'Rediscover Mitcham' Town Centre Regeneration Project – outcome of the Traffic Management Orders Statutory consultation.

Subject: 'Rediscover Mitcham' town centre regeneration project – Traffic

Management Orders (TMOs) statutory consultation outcome.

### General arrangement drawing no. Z91-12-01

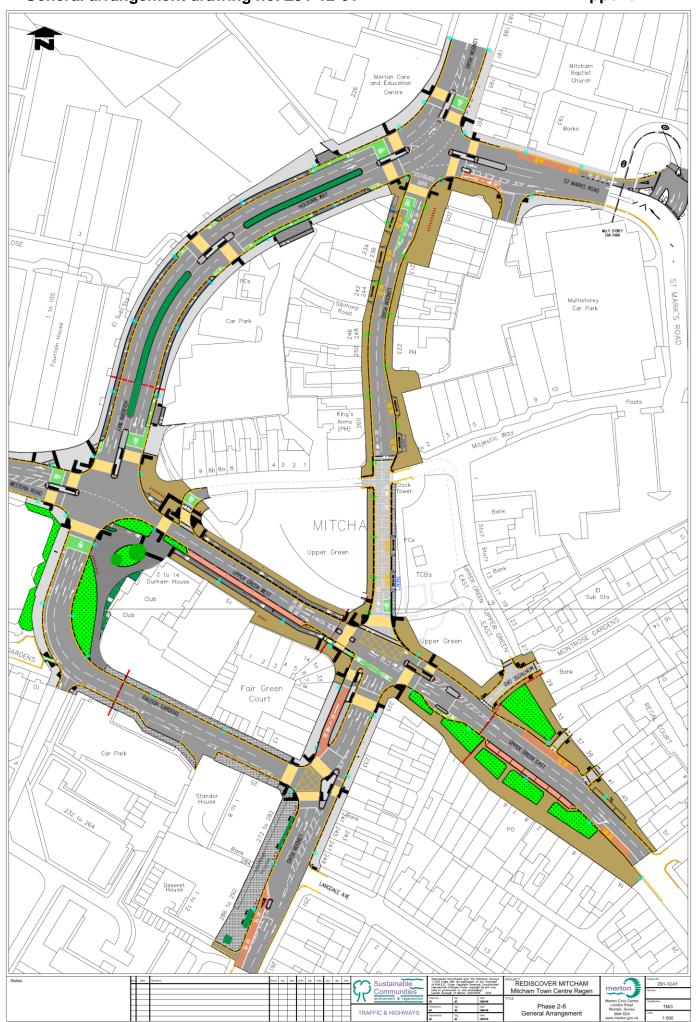
I object to the shortening of the bus lane on London Road so that it begins adjacent to Chatsworth Place and ends south of Langdale Avenue. The bus lane should continue all of the way along London Road to meet the new section of bus lane, north of Raleigh Gardens. By creating a lacuna in the bus lane, not only will you frustrate the progress of a bus lane's priority vehicles, you create a section approaching a junction where cyclists will be sharing the carriageway lane with motor vehicles. This is not intelligent, disincentivizes cycling, and increases the risk of collisions with cyclists.

I object to the proposal to prohibit the use of the bus lane on London Road between Chatsworth Place and Langdale Avenue by motorcycles. It is now generally accepted that, unless there are specific reasons, motorcycles should be permitted to use bus lanes, as they are vulnerable road users, and to encourage use of motorcycles. If the reason you propose to prohibit the use of this bus lane by motorcycles is because you intend, by use of a traffic light, to alternate the progression of bus lane traffic with the all-vehicles traffic at the section of London

I am concerned with the changes to Raleigh Gardens. Will there not be any bus routes along Raleigh Gardens? If there are, then the bus lane should be retained. If the intention is for there to be no bus routes along Raleigh Gardens, then the proposed cycle lanes, as well as the cycle lanes on Holborn Way, are questionable as they do not look like they are at least 2.0 metres wide, in accordance with the Department for Transport's Cycle Infrastructure Design recommendation for busy There also does not seem to be a dooring buffer of 0.5 - 1.0 metres incorporated between the loading bay on Raleigh Gardens and the cycle lane, or between the cycle lanes and proposed parking places on Upper Green West and Upper Green East, again in accordance with the Department for Transport's Cycle Infrastructure Design recommendation for all cycle lanes. The proposed cycle lane which passes the nearside of the parking places on Upper Green West is particularly insidious as there is no opportunity for cyclists to cycle 2.0 metres away from the parked cars. This section of Upper Green West, which will only provide parking for nine cars, is not only dangerous for pedal cyclists, it will also cause undue frustration and danger for the motor vehicles attempting to travel east, and intending to turn right on to London Road, as there will be only one new eastbound lane so all traffic will have to stop, to allow cars to reverse park into the parking places. Providing car parking is commendable but this is definitely not the place, so these on-road car spaces should be excluded from the plan. The section in question should instead be a green buffer zone between the (now 2.0 metres wide) cycle lane and the carriageway.

Within the TM Plans/drawings provided, there are no road signs shown in relation to the proposed 20 mph speed limit - how is this going to be marked (e.g. 20mph roundels/repeaters) and are there any further traffic calming measures planned?

There appears to be no key for the TM drawings? There are no lane widths/cycle lane widths shown.

London Road j/w Raleigh Gardens - Longitudinal direction arrows (diagram 1038) indicate all traffic to turn left into Raleigh Gardens. How are buses and cycles directed straight ahead?

Raleigh Gardens j/w road leading to Glebe Court/Tudor Court - no cycle lane diagrams (diagram 1057) at junction to indicate cycle lane

Cycle lane in shared space leading from Upper Green West towards Western Road the lane stops prior to the junction with Raleigh Gardens. Where do cyclists go from there?

Holborn Way - what are the widths of the cycle and traffic lanes?

Upper Green West j/w London Road cycle lane (east bound) - the diagram is unclear. Do cyclists ride over the tactile blister paving, or do they re-join the carriageway heading east bound? Can they trun left into London Road, and if so, do they use the footway or re-join the carriageway?

Upper Green West, west bound cycle gateway - this appears to be ATS controlled - what is the lane width, is there room for cyclists to enter the gateway safely without coming into contact with large vehicles? The longitudinal direction arrows indicate all traffic left into London Road - how are buses and cycles directed straight ahead (to turn right into London Road)?

The shortening of the Bus Lane in London Road near its junction to Langdale Avenue is to accommodate the north bound bus gateway, giving buses sufficient distance and priority over general traffic (stopped at a red light) to approach the junction with Raleigh Gardens and move to the far side lane in order to access the bus contra-flow towards Upper Green West / East.

The proposal to prohibit motorcycles from the north bound bus lane in London Road on approach to the bus gate was to reduce the risk of motorcyclists suddenly manoeuvring out of the lane back into the general traffic flow to benefit from a green light, rather than give-way at the end of the bus lane. However, this has been

reconsidered and motorcycles will be permitted to use the bus lane, although this will be monitored and if any safety concerns arise, it will need to be re-addressed. Motorcyclist would still be prohibited to use the bus contra flow between Raleigh Gardens and Upper Green West as mentioned by the objector.

Since all bus routes currently using Raleigh Gardens will be removed from this road, there is no need for a bus lane. In order to maintain the same number of suitable traffic lane and footway widths, the cycle lanes are 1.5m. This is a minimum requirement in accordance to Transport for London's Cycle Design Standards (LCDS). The use of preferred dimensions is always initially considered during the first stages of any design, however these are not always possible to achieve without a negative impact primarily due to London's restrictive urban environment. These cycle facilities have been developed with the Cycling Delivery Planning section of TfL, who are also responsible for updating the LCDS.

A buffer or dooring zone in Raleigh Gardens at the loading bay has been provided with a 0.7m added to the cycle lane at 2.2m wide. Along the parking layby in Upper Green West a 0.5m buffer zone is provided, although not clearly seen in general arrangement plan.

Plans that accompany TMO notifications and those placed on deposit only show the general layout and information and do not contain such details such as signage, which can cause confusion to the lay person.

The plans are normally also to scale so that any required dimensions can be measured. However, a detailed plan was emailed to the Police and other emergency services on 4 April 2015, which shows the key dimensions.

Due to the size of the scheme, it was not possible to display all the signage without overcrowding the plan and becoming eligible. To clarify, northbound buses proceeding past Raleigh Gardens will be guided by directional signage and aspects on the traffic signals.

Cyclists leading from Upper Green West towards Western Road will be able to use the contra-flow cycle track on approach to Raleigh Gardens, where they will receive a dedicated cycle signal to take them across the junction to Western Road

The key widths in Holborn Way are 1.5m cycle tracks, 3m carriageway with 2.6m traffic islands. Upper Green West j/w London Road cycle lane (east bound) does merge through the crossing points and cyclists can turn left into the bus street using the dropped footway and tactiles at the formal crossing points leading into the bus street.

Upper Green West, west bound cycle gateway will be controlled by ATS (signals), with cyclists given earlier release and traffic held back in order to access the Upper Green West contra-flow. Buses turning right will be directed in the same fashion and described above.
